MOOLARBEN COAL PROJECT

Response to Submissions

Director General's Requirements

Suggested locations for PM10 monitors

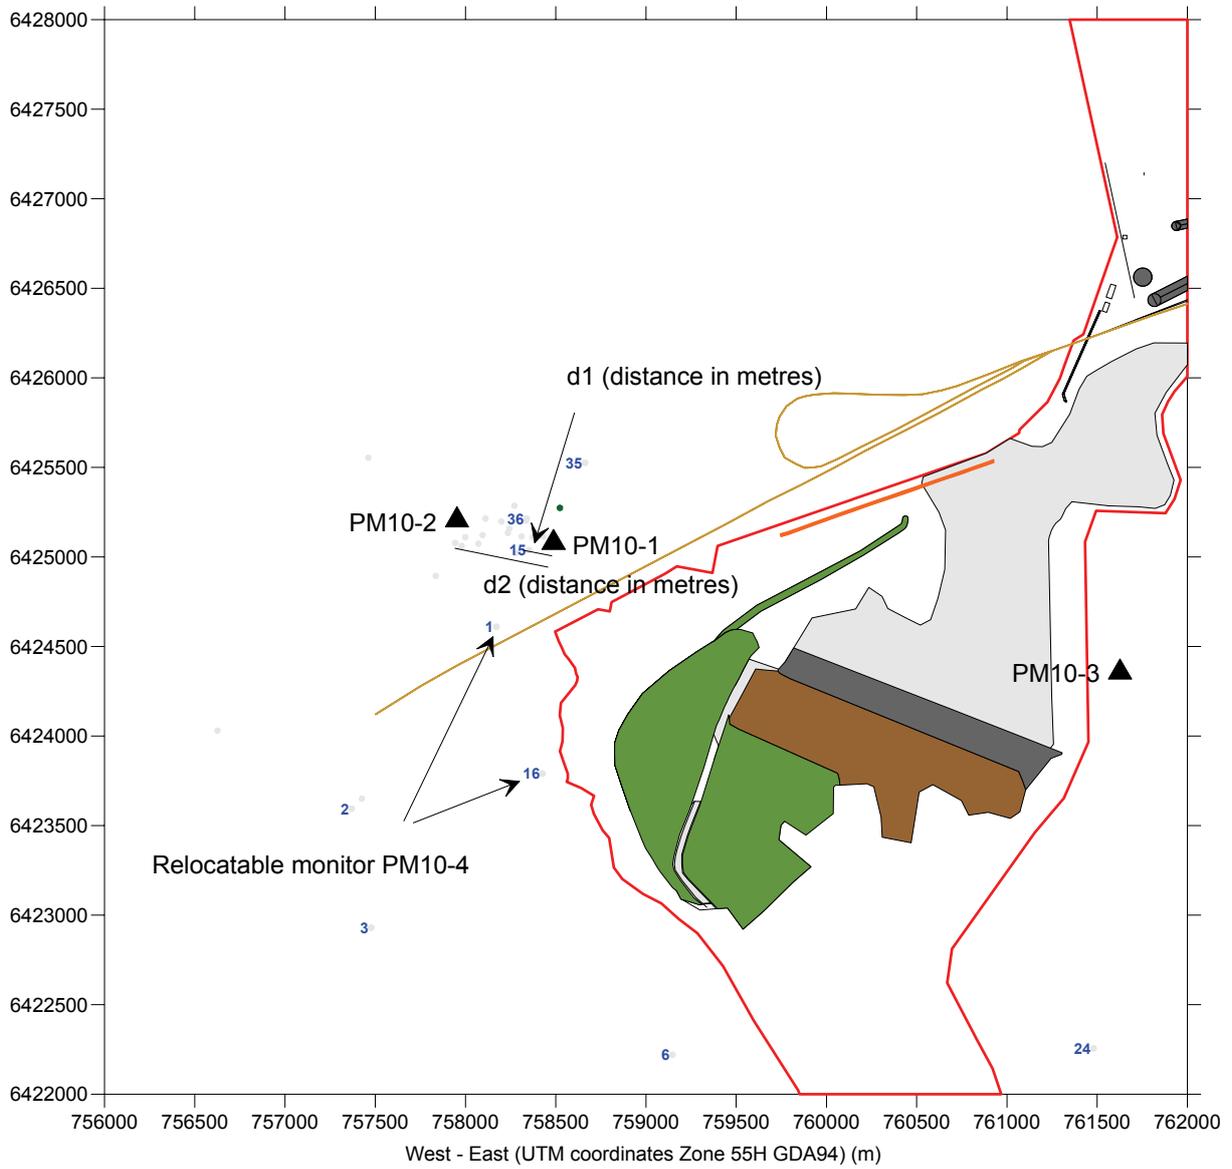
The general principles set out in the DEC's proposed Dynamic Dust Management Plan (see bottom of Page 11 of the DEC submission) (in relation to monitoring of meteorological and air quality conditions and the development of a dynamic management plant) are accepted. However, the final paragraph labelled 2 requires that a study is to be undertaken by a suitably qualified person to establish a readily identifiable indication that 90% control of dust is being achieved.

Most of the monitoring data used in the EIS was collected in 2006. Thus some of the possible 2 to 3 µg/m³ is already accounted for in the existing monitoring because UCML is estimated to produce 7.5 Mtpa ROM in 2006. If this is taken to be 58% of the potential 13 Mtpa ROM then approximately 1.2 to 1.7 µg/m³ of the 2 to 3 µg/m³ would already be accounted for leaving 0.8 to 1.3 µg/m³ not accounted for in the monitoring. This is a relatively modest increment, it would not be unreasonable to deal with this level of uncertainty using the proposed monitoring, and property acquisition plan referred to above.

The potentially unaccounted effect from UCML would certainly be less than the reduction that would occur if Moolarben were to operate the haul roads with a control level at 90% rather than the 75% actually assumed.
